September 22, 2020
Medway Planning & Economic Development Board
Meeting

Country Cottage Child Care Center
Field Change Authorization

Medway Place Site Plan Public Hearing

Re: **Harmony Village**
218-220 Main Street, Medway, Massachusetts
Response to Tetra Tech comments
MAI Project No. 8521

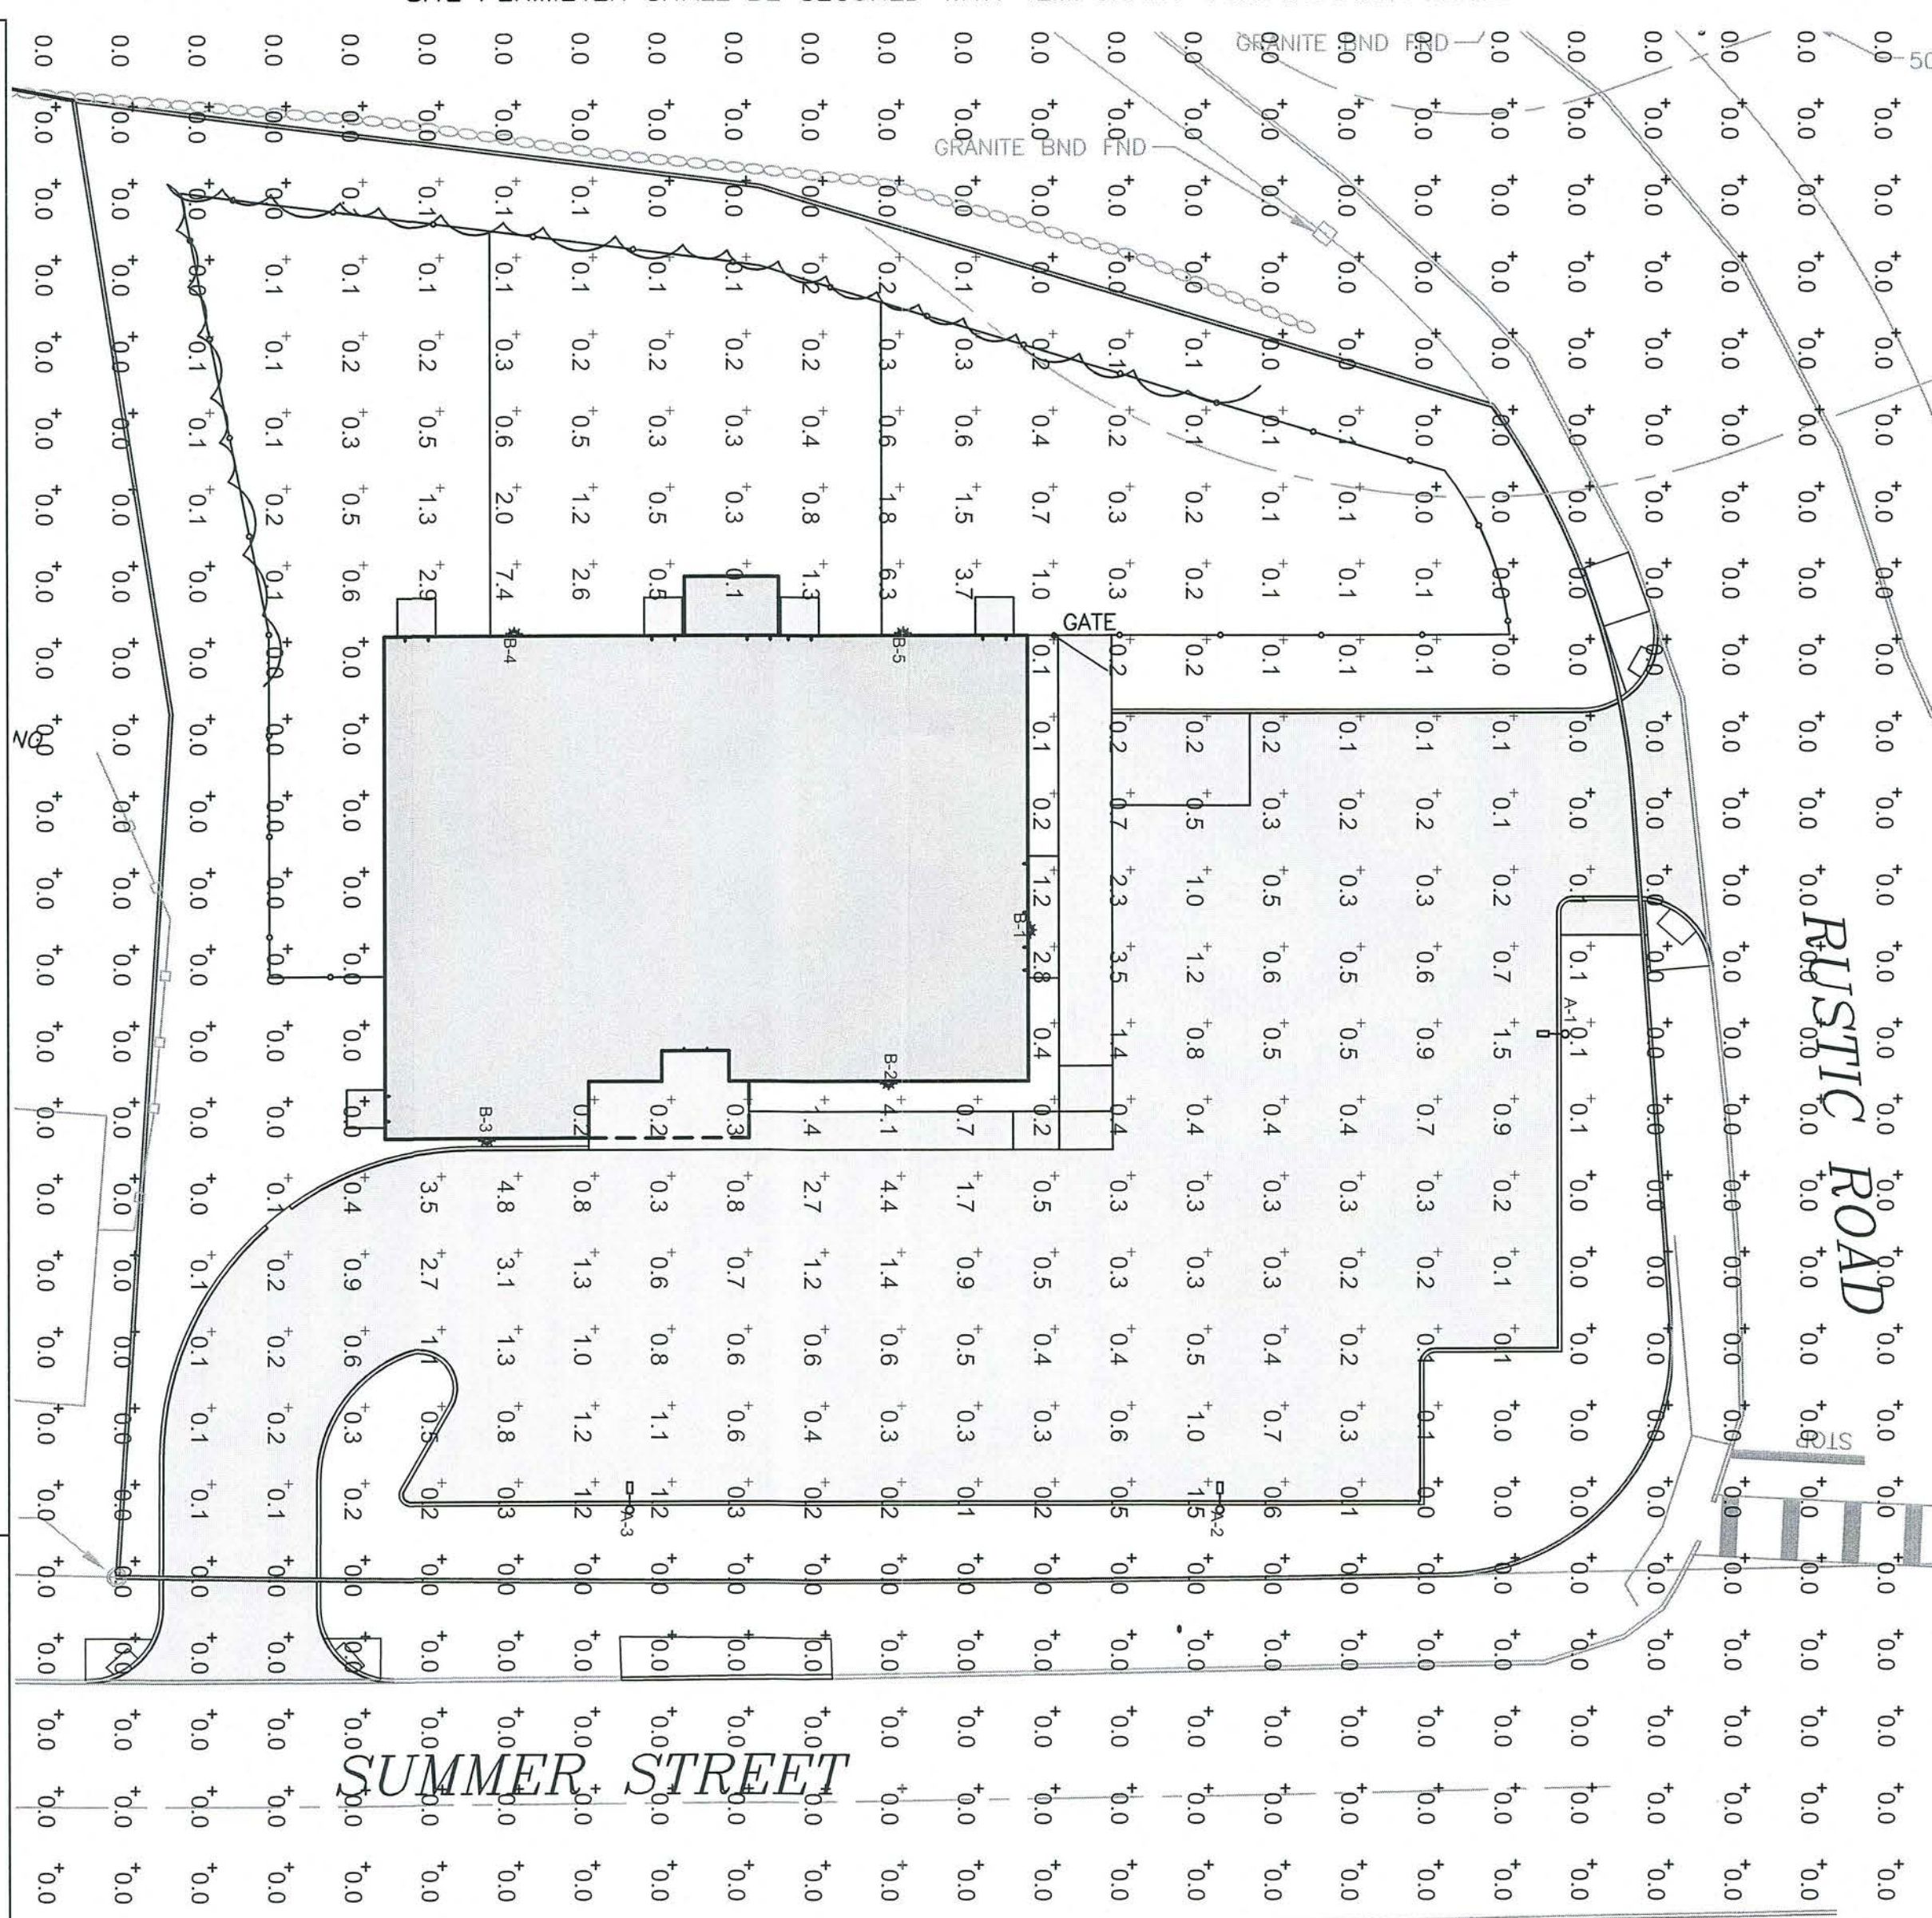
Upon reviewing a punch list provided by Tetra Tech, I would like to request a field change to item #5 under missing items. Tetra Tech has noted that a Green Giant Arborvitae has not been planted nor has the landscaping been completed south of the site egress to Summer Street.

Upon conversation with our southerly neighbor, Judy Notturmo of 33 Summer Street, we learned that they did not want their view blocked from their side or front windows. To keep good will with our neighbor, we eliminated some of the proposed plantings, including the Green Giant Arborvitae. We also addressed their concern by extending our fencing in a manner that does not block the view from their window.

LANDSCAPE PLAN
Multifamily Development
218-220 MAIN STREET
MEDWAY, MA 02053
Prepared For:
Harmony Village LLC

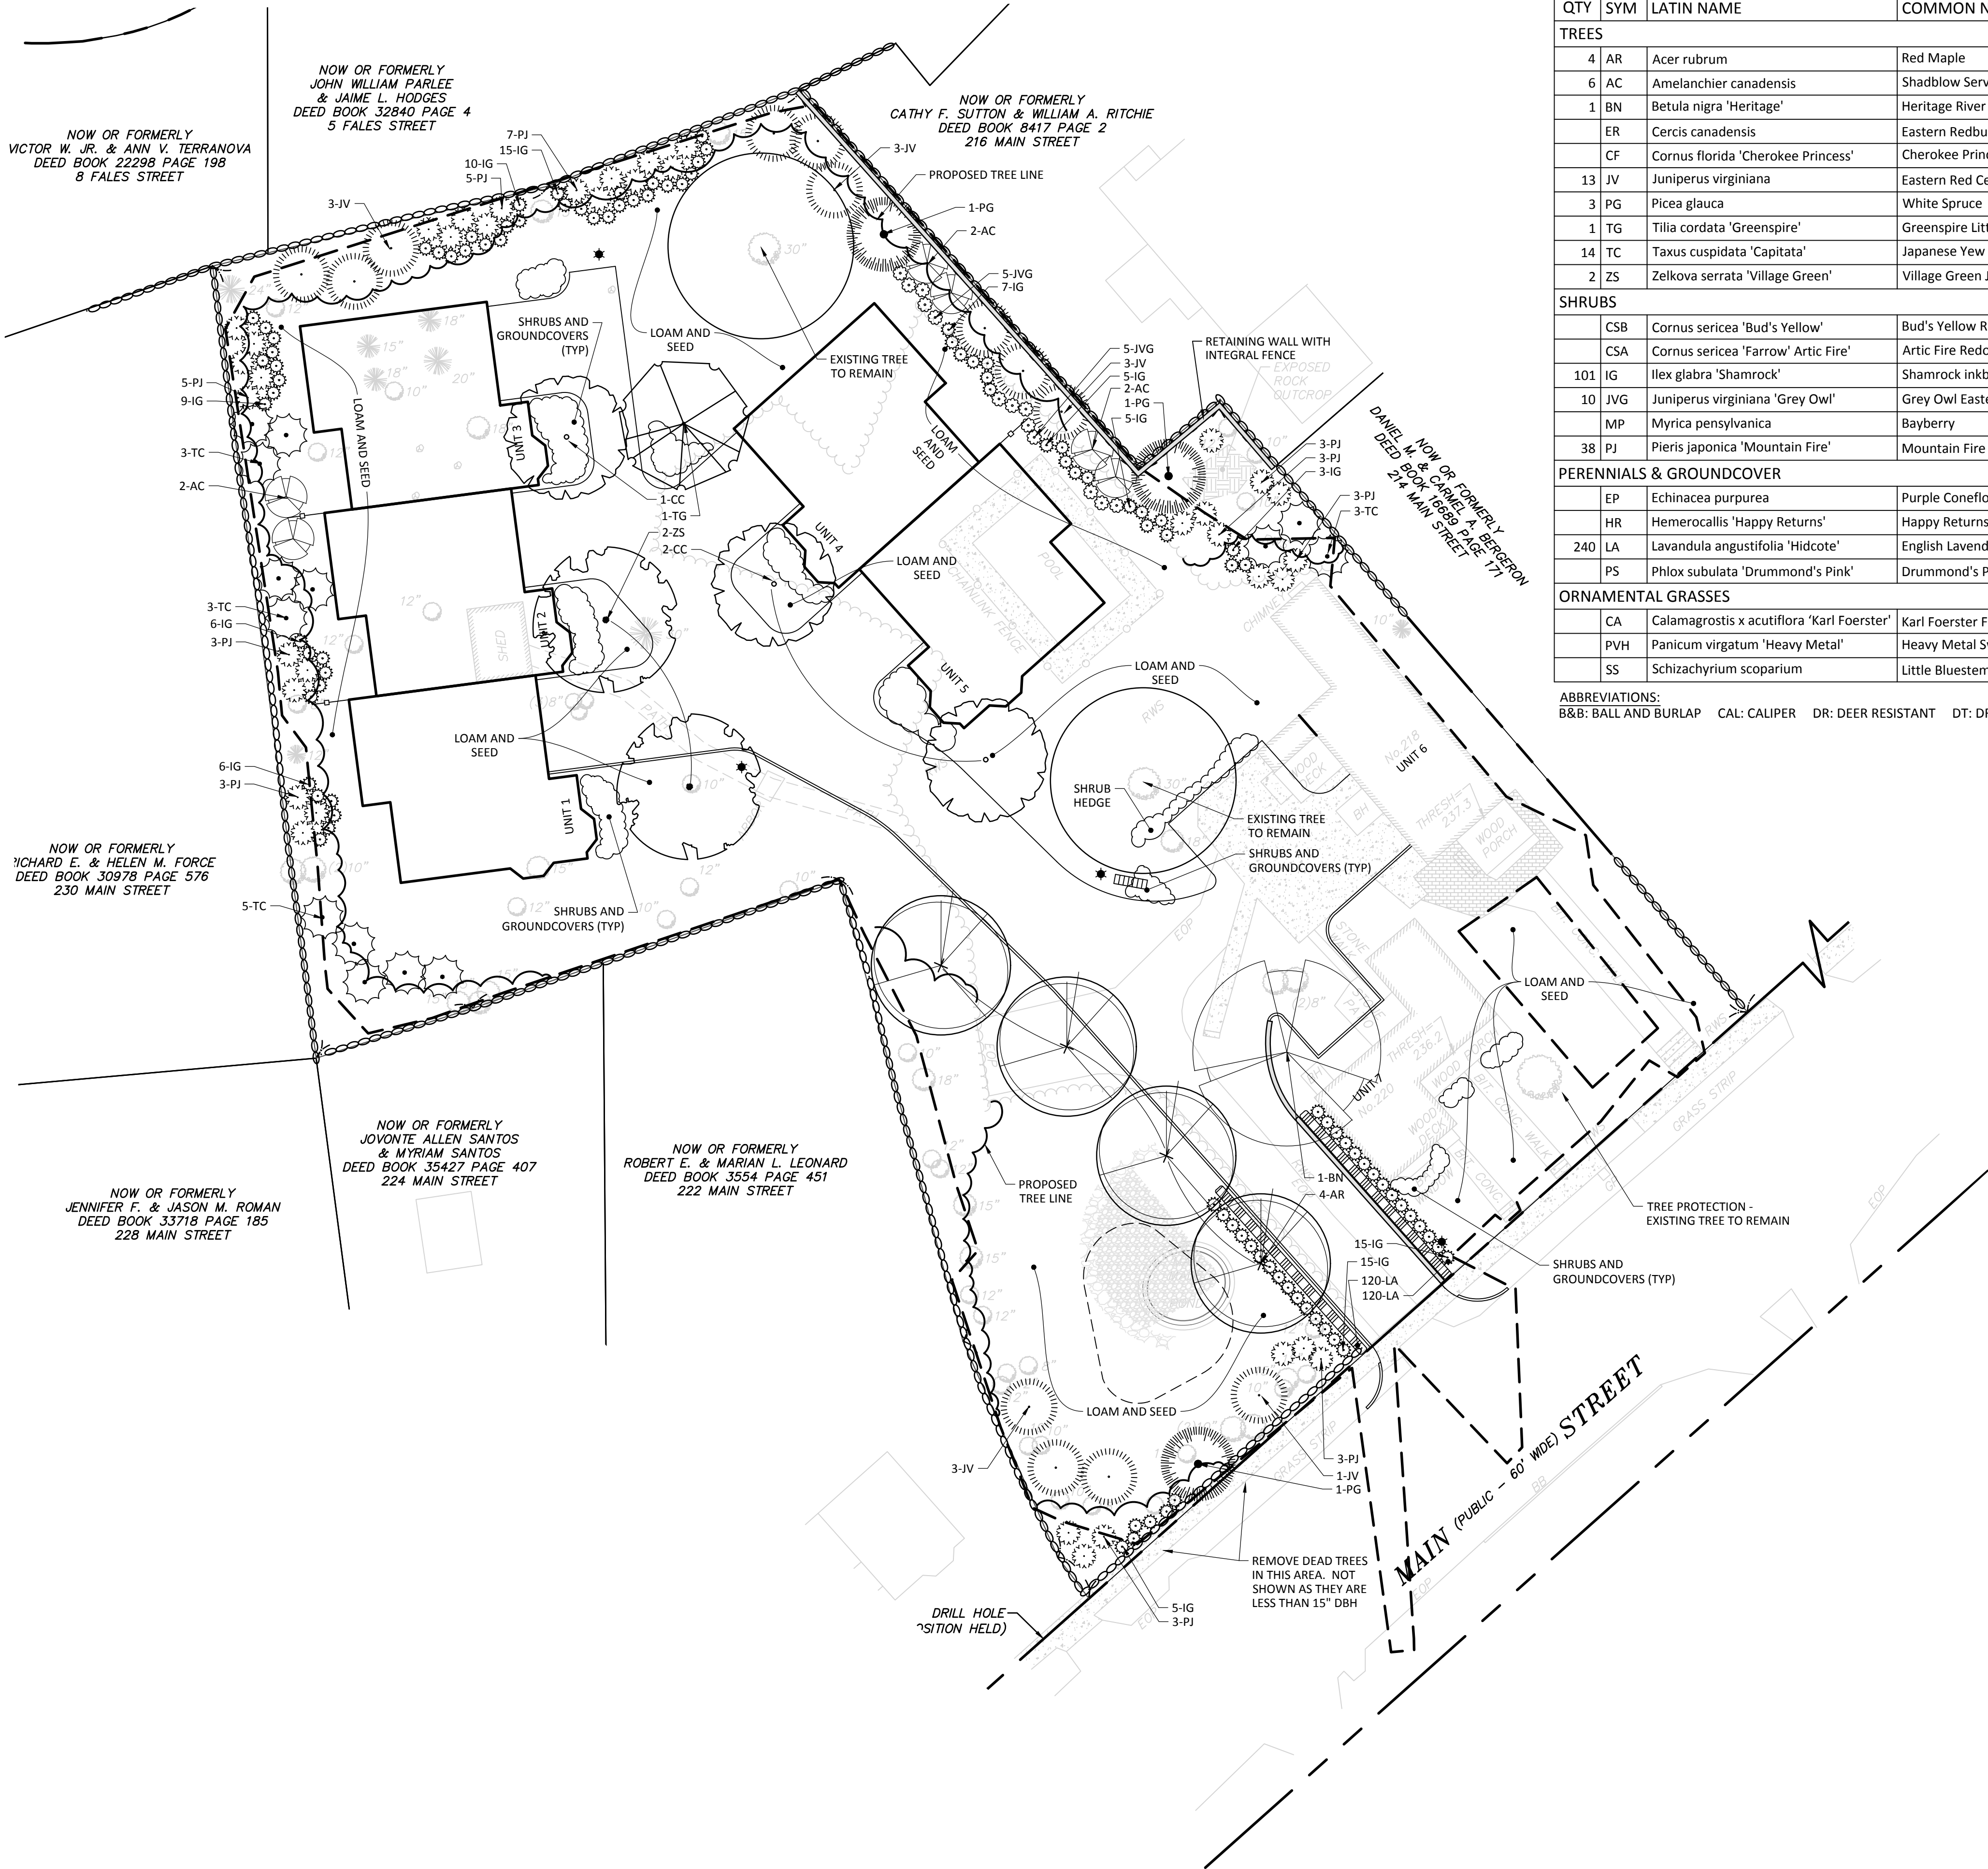
22. A photometric plan and lighting details shall be provided.
23. The Landscape plan has been improved to provide a 15 foot buffer.
24. The proposed basin (DB-1) has been redesigned to salvage as many existing trees as possible and additional landscaping has been provided.

13. A Landscape Plan was prepared and has been revised to incorporate increased buffering.
14. Notes have been added to the Landscape Plan for maintenance and installation.
